Village of Arlington Heights
Plan Commission
Board Room
Arlington Heights Village Hall
33 S. Arlington Heights Road
Arlington Heights, IL 60005
October 25, 2017
7:30 PM

- A. St. Edna Church - 2525 N. Arlington Heights Rd. - PC#17-010
PUD Amendment

File Number: PC# 17-010
Project Title: St. Edna's Catholic Church
Address: 2525 N. Arlington Heights Rd.
PIN: 03-17-101-019

NEW ADDITION AND INTERIOR RENOVATIONS TO:
ST. EDNA CATHOLIC CHURCH
2525 N. ARLINGTON HEIGHTS RD. ARLINGTON HEIGHTS, IL 60004

NO.	DESCRIPTION	DATE
FIRE ALARM PLAN		
DRAWN: AT, BC, KM		PLOT DATE: 05/01/2017
CHECKED: SIT	E3.1	
JOB NUMBER: M16025

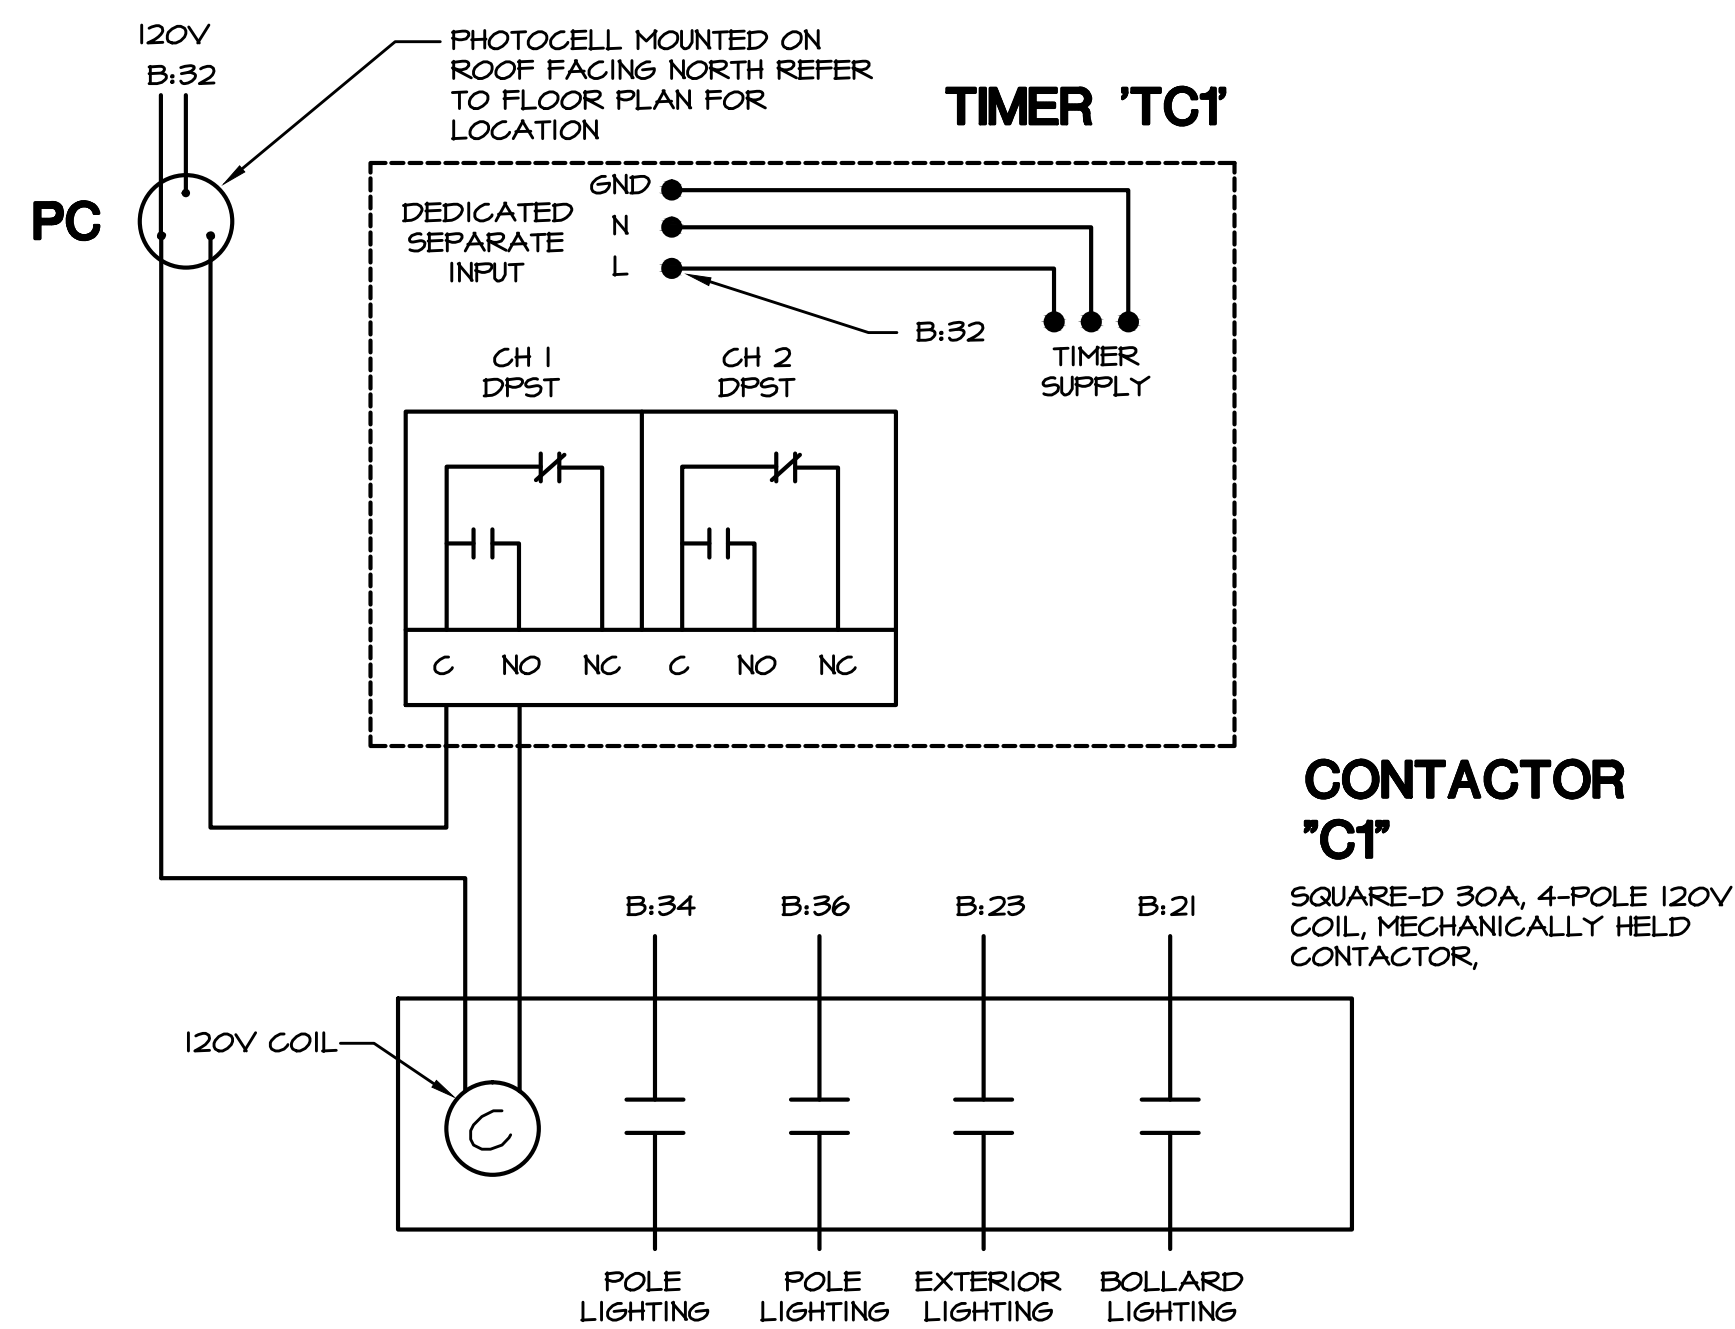
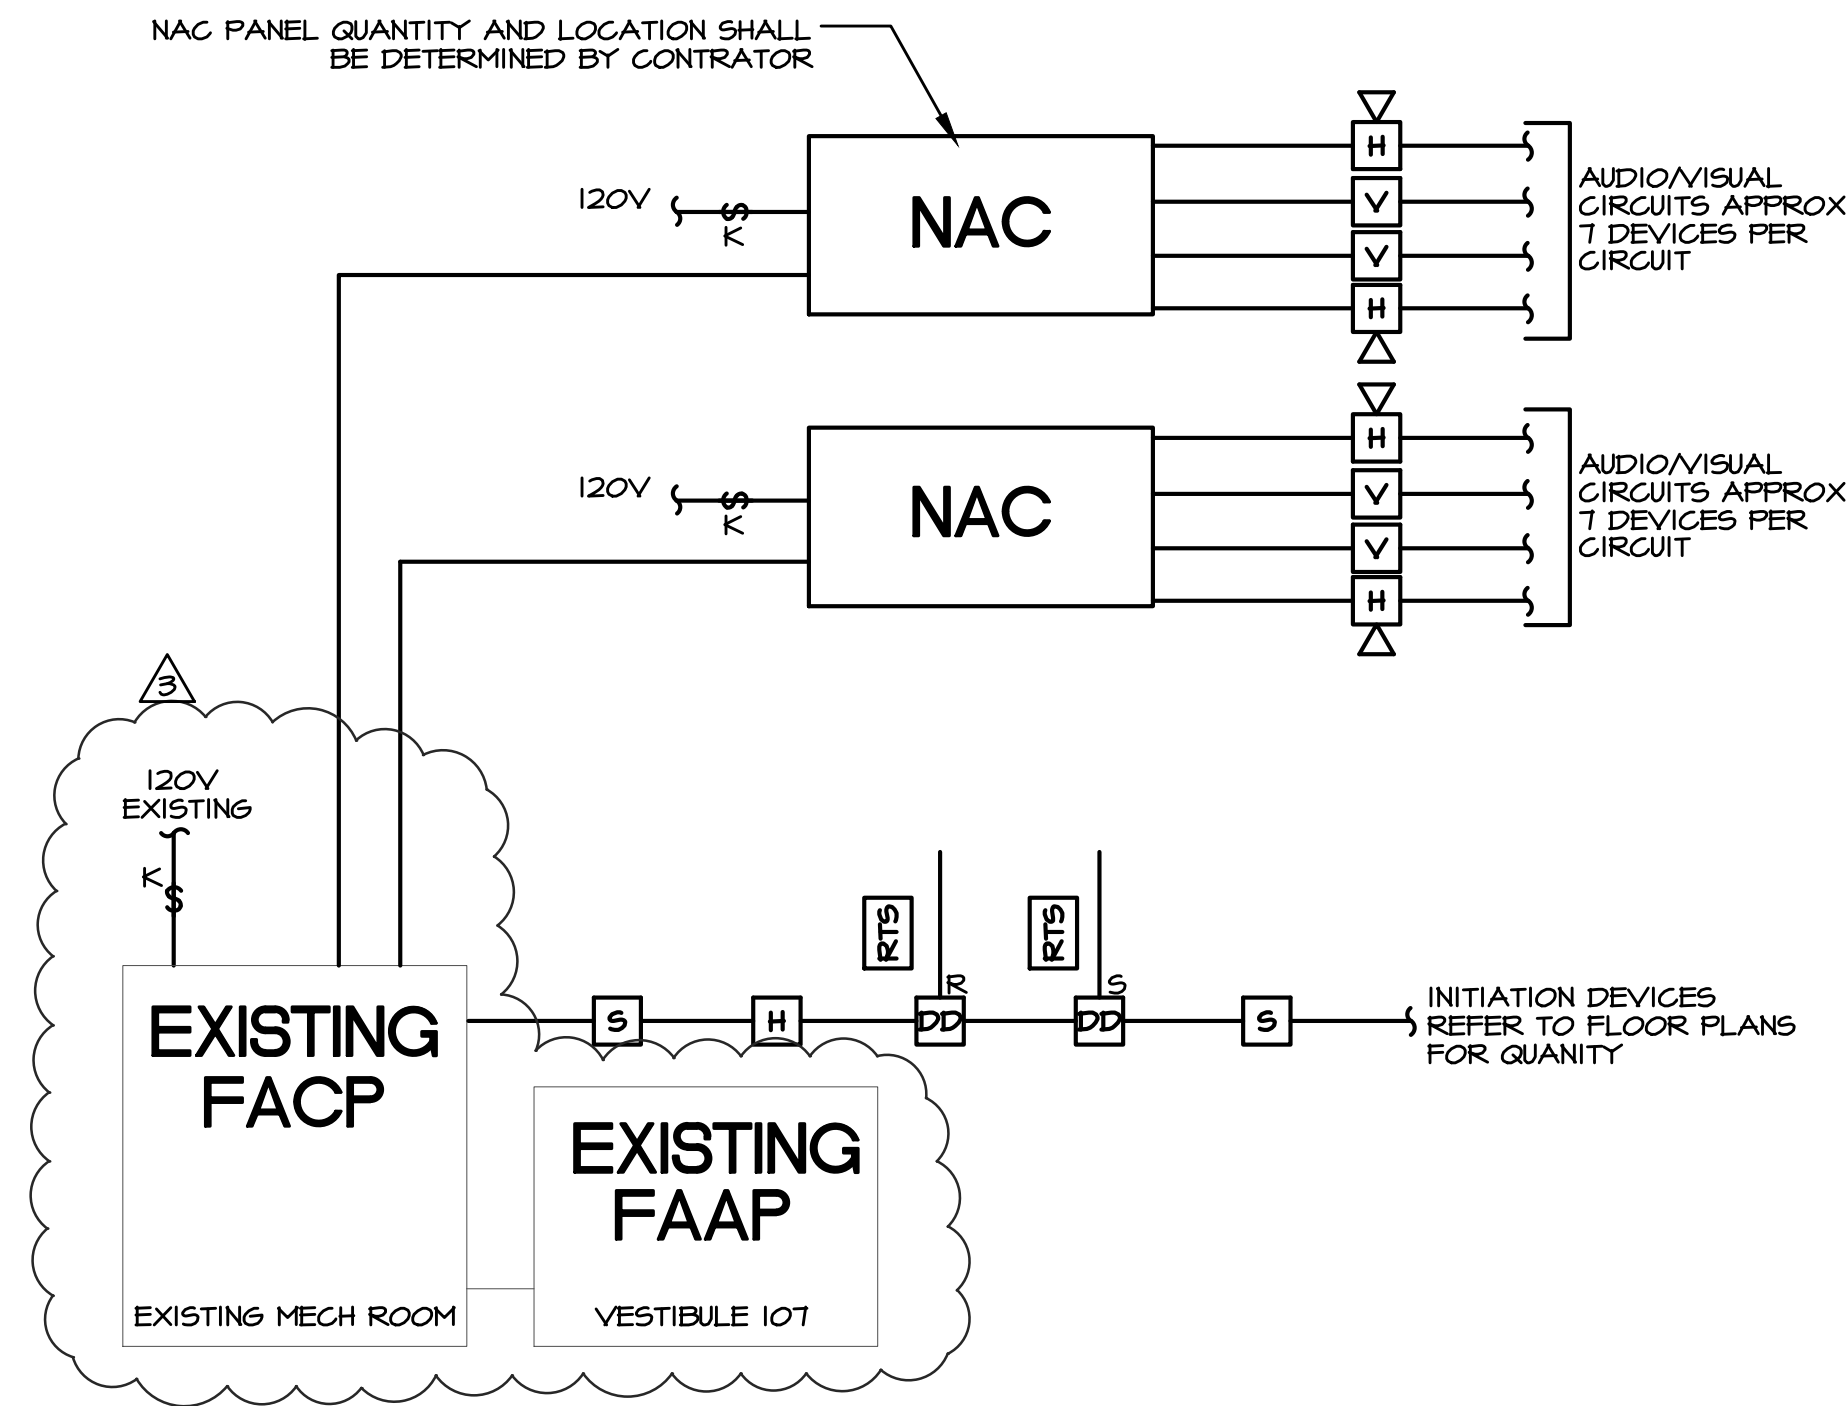
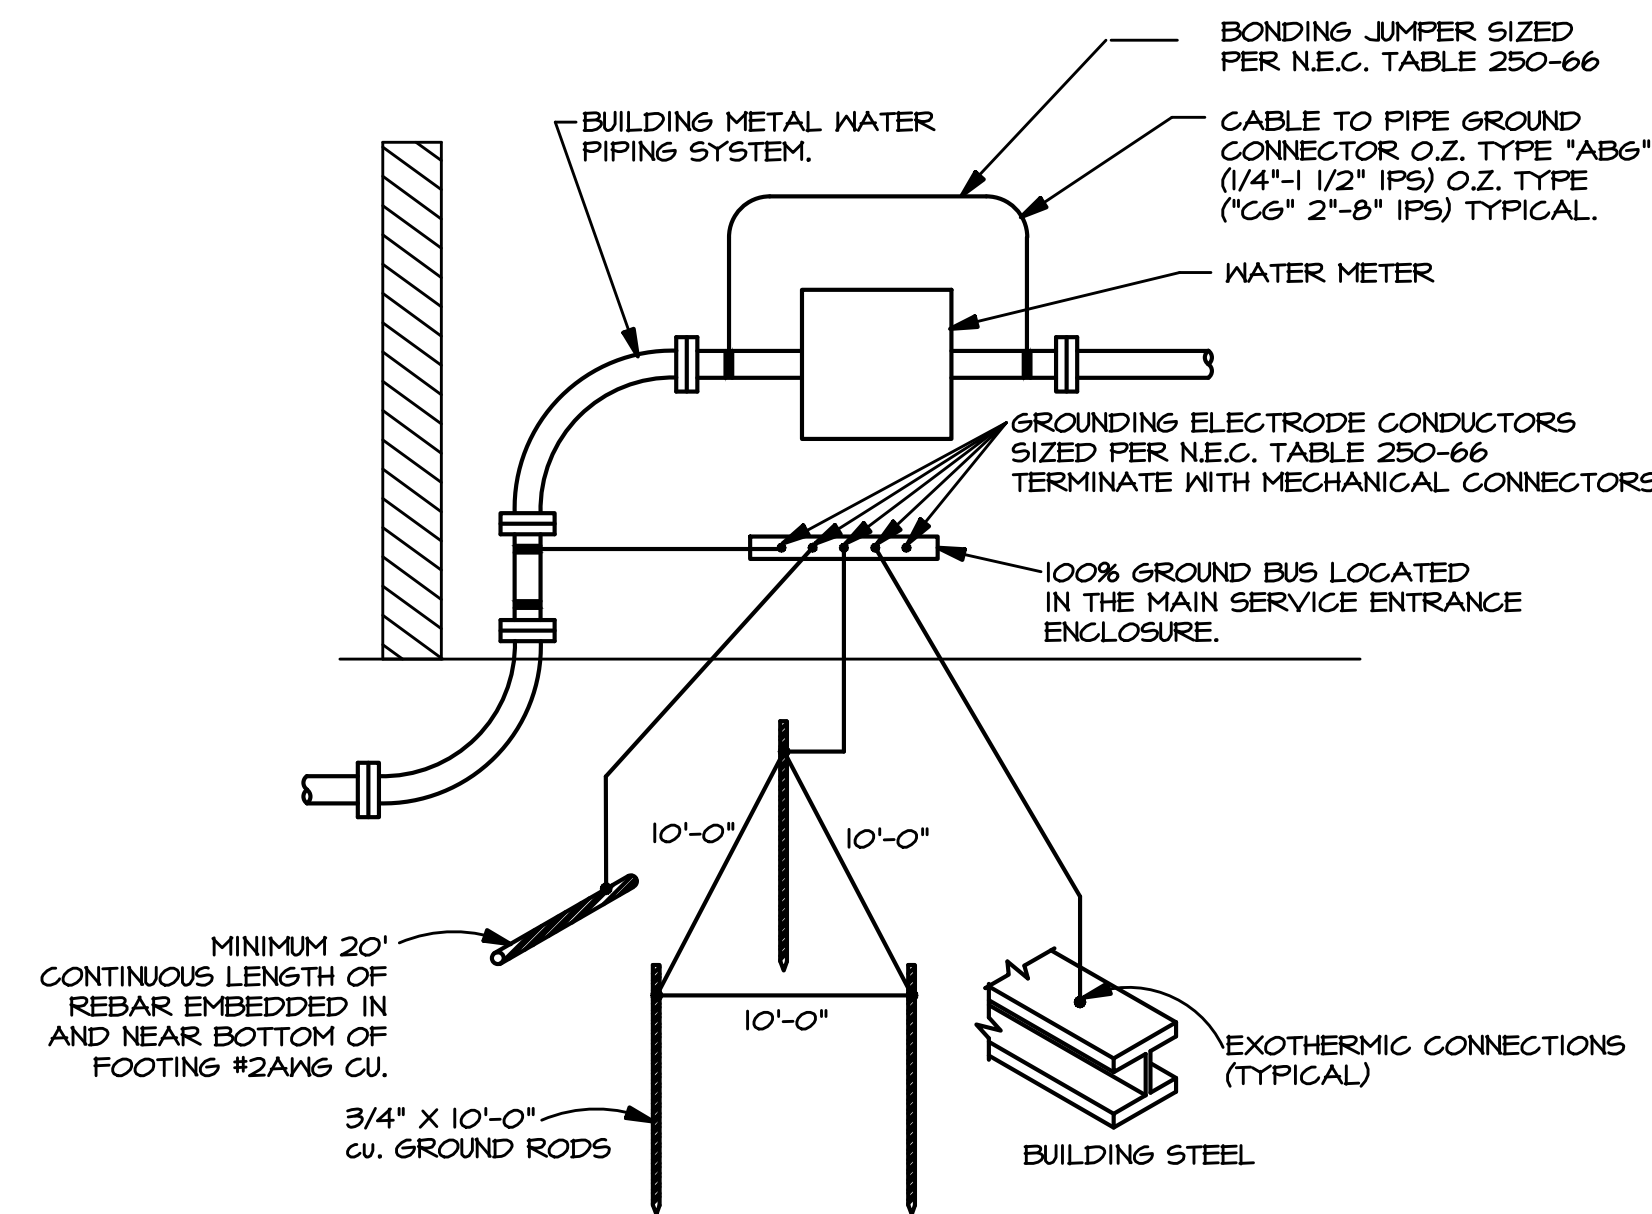
5. A complete fire alarm system is required and will be required to be connected to the existing structure.
A complete fire alarm system will be provided and will be connected to the existing fire alarm system. See revised sheets E3.1 and E4.1

An addressable system was installed in the existing building in 2002. A complete fire alarm system has been provided in the new building and will be connected to the aforementioned existing fire alarm system. See revised sheet E3.1 and E4.1
